# Clepsidra

550cc

PrintArea

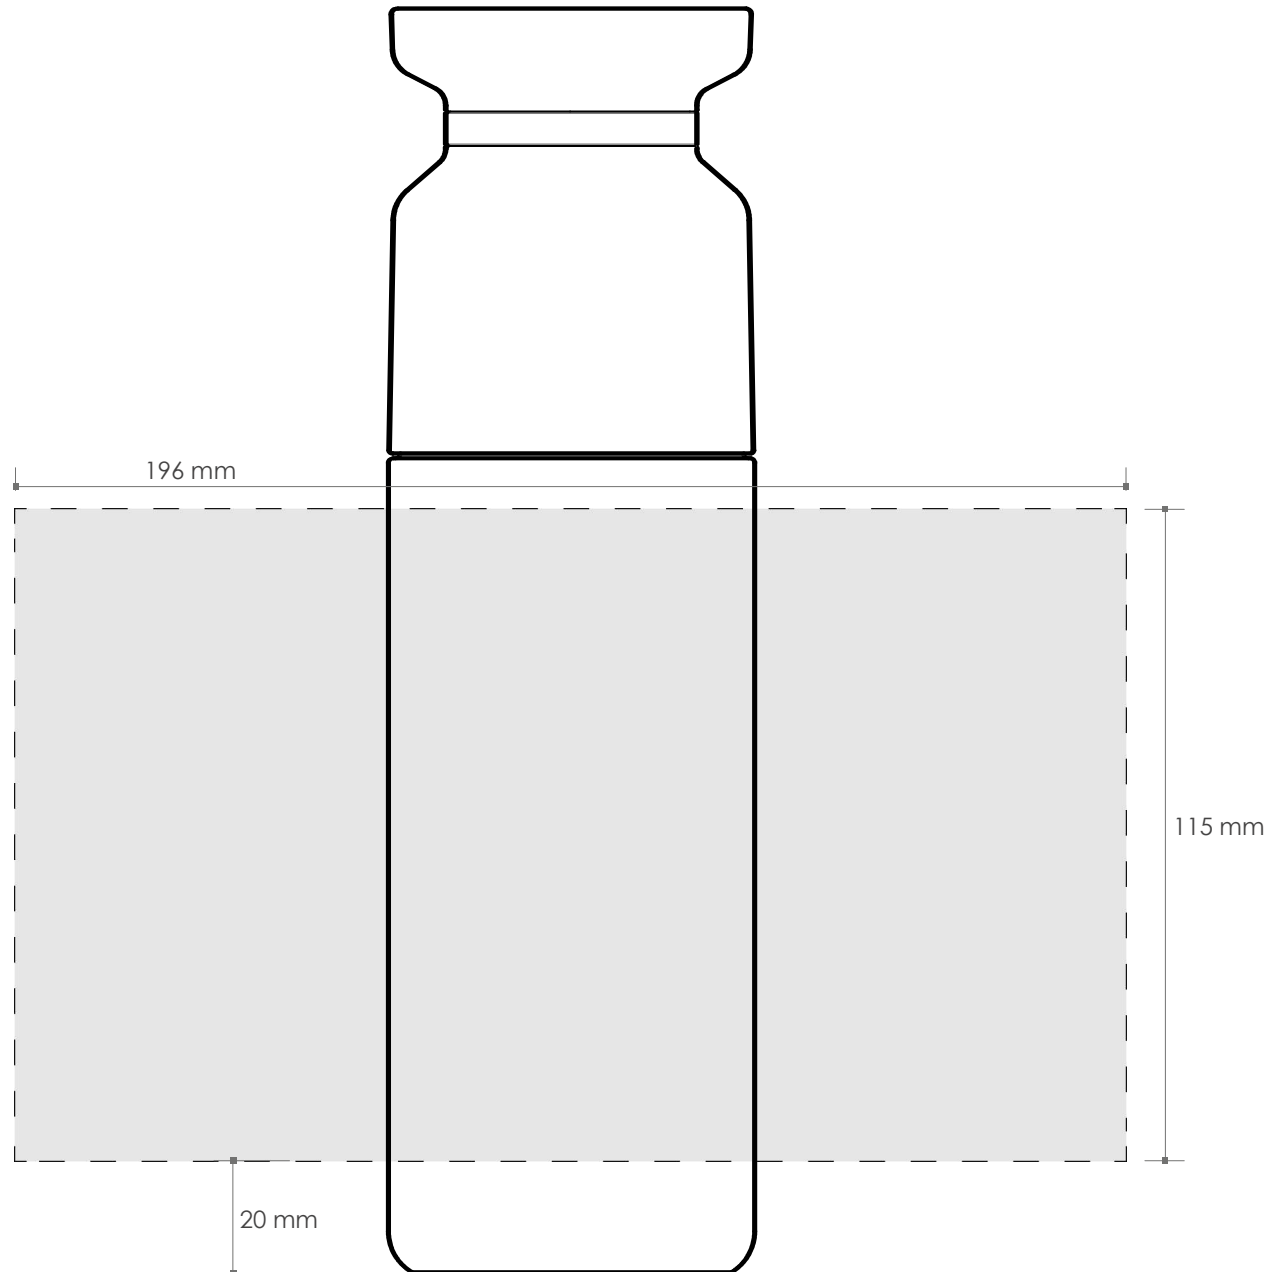
The impression can not close on the circumference of the bottle:  
it's necessary to consider a non -printable area (approx. 0,8 cm widht)
